Re. Proposed seniors housing development, 27 Bellevue Ave, Avalon Beach – Schedule of amendments to civil drawings

Summary of amendments to civil drawings:

| TITLE | | | | |
|-------------------------------------|----------------|------------------------|------------------|-----------------------|
| STORMWATER DRAINAGE CONCEPT PLAN | | | | |

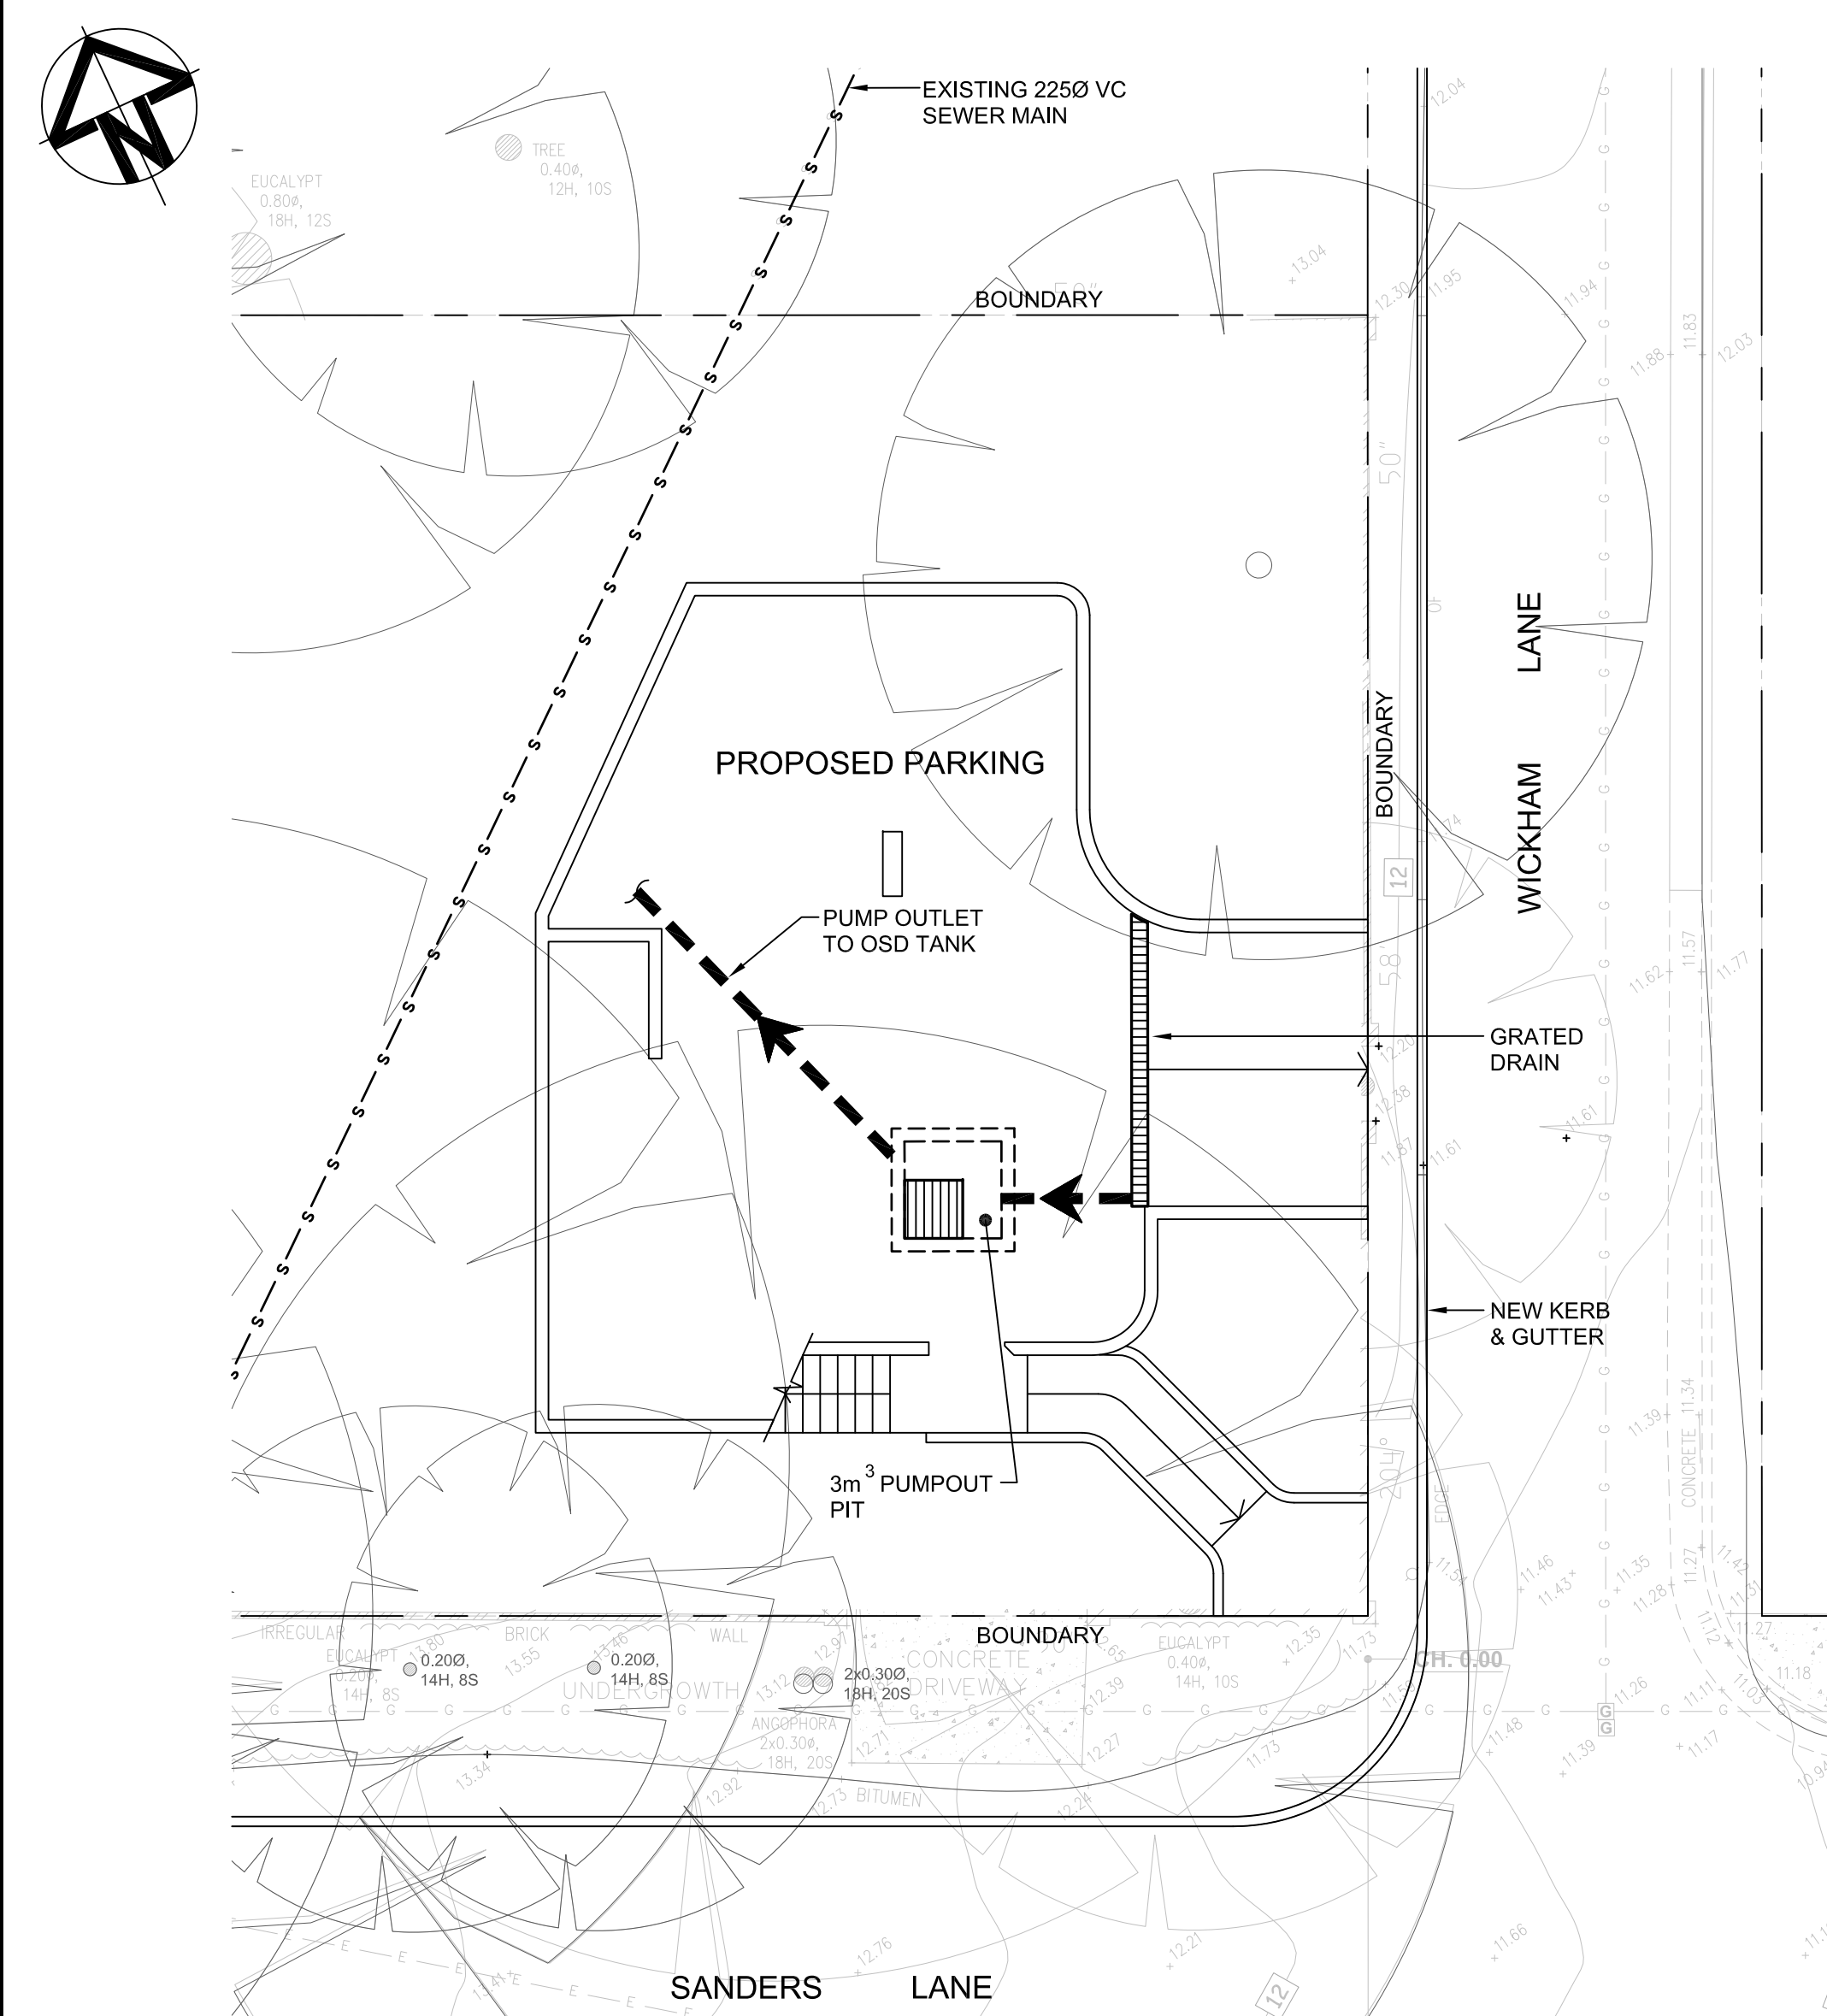
Drawing C05 rev 6

- Stormwater drainage pits & drainage lines amended to minimise impact on Trees T21 & 33 and method of installation stormwater drainage system specified to minimise impact on the TPZ. Bio-retention basin location to Ground Floor level revised.

Drawings C05 rev 7, C06 rev 2, C10 rev 13 & C11 rev 3

- The “ears” have been removed from the drawing.
- The stormwater line adjacent to T33 has been moved to the northern boundary in the existing wall footing trench.
- The kerb on the east side of Wickham Lane has been relocated to allow the turning of a truck travelling south on Wickham Lane into Sanders Lane.
